MARKED UP PAGES FOR PROPOSED CHANGES TO APPENDIX A TECHNICAL SPECIFICATIONS OF FACILITY OPERATING LICENSES NPF-72 AND NPF-77

BRAIDWOOD STATION UNITS 1 & 2 REVISED PAGES:

Figure 1. Braidwood Unit 1 Reactor Coolant System Heatup Limitations (Heat up rate up to 100°F/hr) Applicable for the First 32 EFPY (With Margins 10°F and 60 psig for Instrumentation Errors)

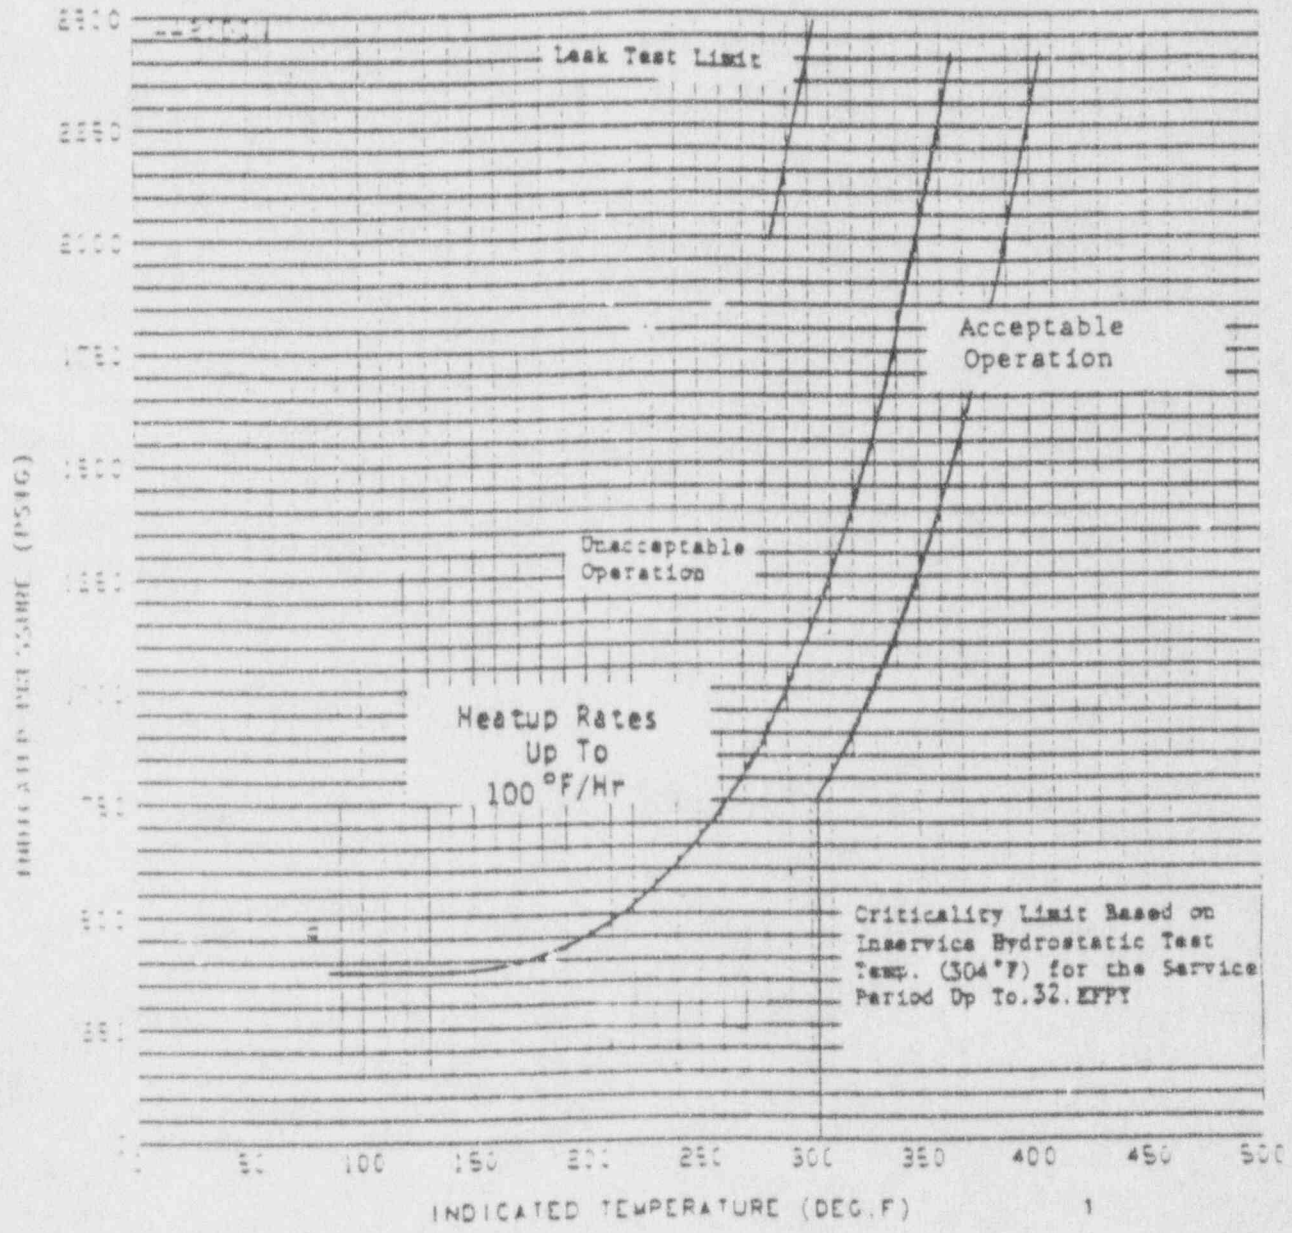
It should be noted that there are two (2) typographical errors on page 10 of the Westinghouse report.

1. 60⁰F/Hr shown on the graph shall be changed to 100⁰F/Hr, and
2. The words "Acceptable Operation" shall be relocated across the Criticality Limit line consistent with the revised Braidwood Unit 2 heatup/cooldown curves.

- o The heatup curve is now identified as 100°F/Hr. It was inadvertently identified as 60°F/Hr.
- o "Acceptable operation" tag has been moved to a different location. This is done as per the customer's request.
